ADDENDUM TO THE ENVIRONMENTAL IMPACT REPORT

FOR THE LACMA BUILDING FOR THE PERMANENT
COLLECTION PROJECT

February 2022

Figure 1
Cooling Tower Pad Diagram

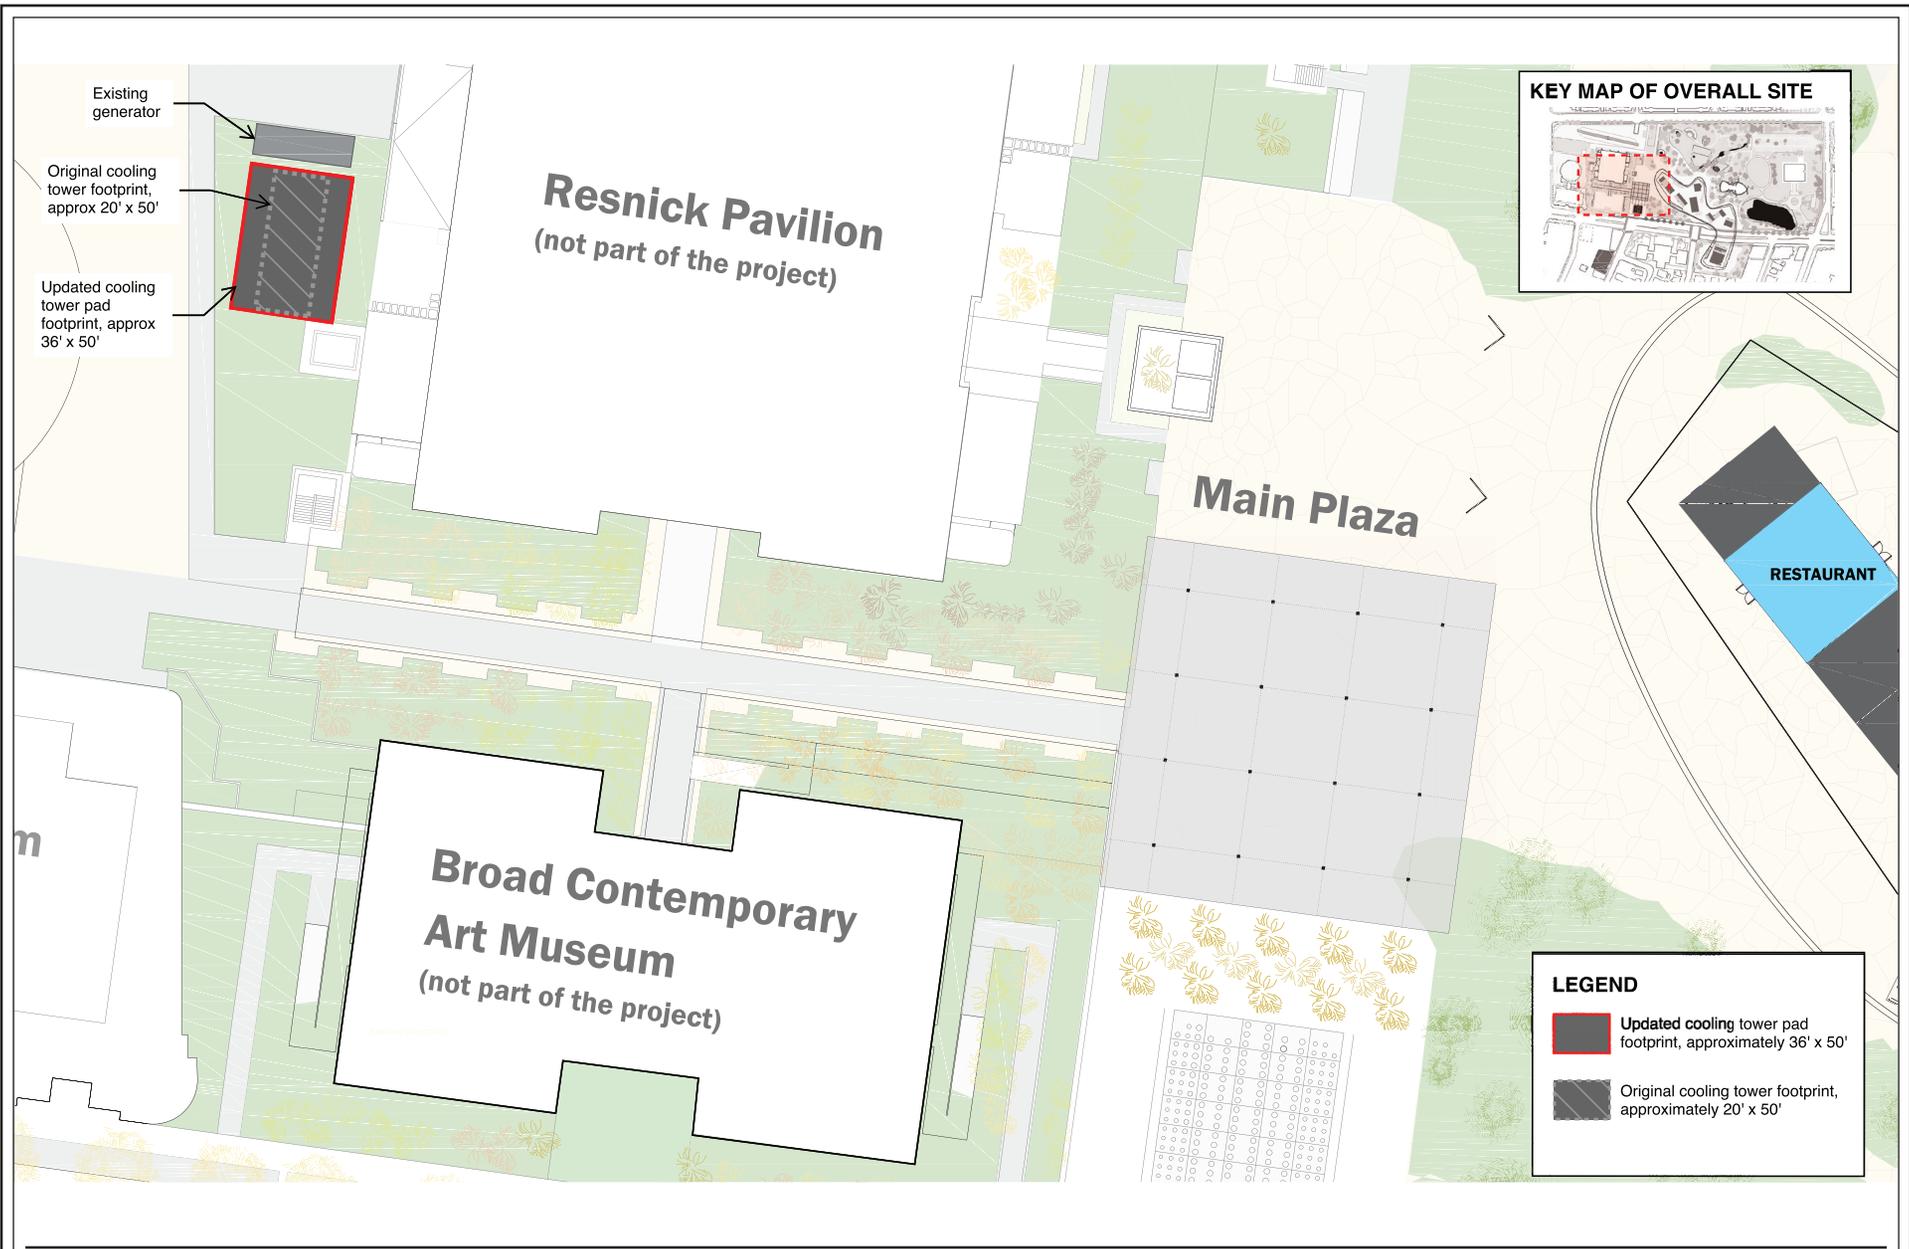
The Modified Project also proposes to expand the size of the cooling tower pad area from approximately 20 feet by 50 feet to a 36-foot by 50-foot pad area. As illustrated in Figure 1 on page 9, the location of the cooling towers would remain immediately west of the Resnick Pavilion on LACMA West, which is located internal to the Project Site, away from streets and building entrances, as discussed in the Certified EIR. The cooling tower pad would be surrounded by a block wall enclosure approximately 13-14 feet tall. The enclosure walls screen the cooling towers from view and lessen the impact of the noise they generate. Overall, the general location, the number of cooling towers, the capacity of the cooling towers, and the length of the cooling tower pad area would remain consistent with the Certified EIR.

The additional width was needed for the cooling tower pad area to meet standard design practices for cooling towers. Specifically, sufficient space between the ends of the cooling towers and the enclosure walls must be available to allow free air flow into the ends of the cooling towers. Without this space, the cooling towers will not draw air sufficiently and will not function properly. While the width of the cooling tower pad area is increased compared to that contemplated in the Draft EIR, the expanded area would continue to be within the overall construction area where excavation was already contemplated for utility lines. As such, no additional excavation or soil export would result from the expanded cooling tower pad area as these activities were already contemplated to occur related to utility installation. Accordingly, the refinements to the cooling tower pad area would not affect the overall construction of the Project or the worst-case day conditions analysis in the Certified EIR, since these activities would be within the peak construction scenario analyzed in the Certified EIR. Additionally, it is noted that the soils in the area of the cooling tower pad were previously disturbed during construction of the Pritzker Garage and Resnick Pavilion. With regard to operation, the cooling tower capacity considered in the Certified EIR to service the proposed Museum Building also would not change as the size of the proposed Museum Building would remain as was evaluated in the Certified EIR. Accordingly, the capacity of the cooling towers has not changed beyond that which was analyzed in the Certified EIR.
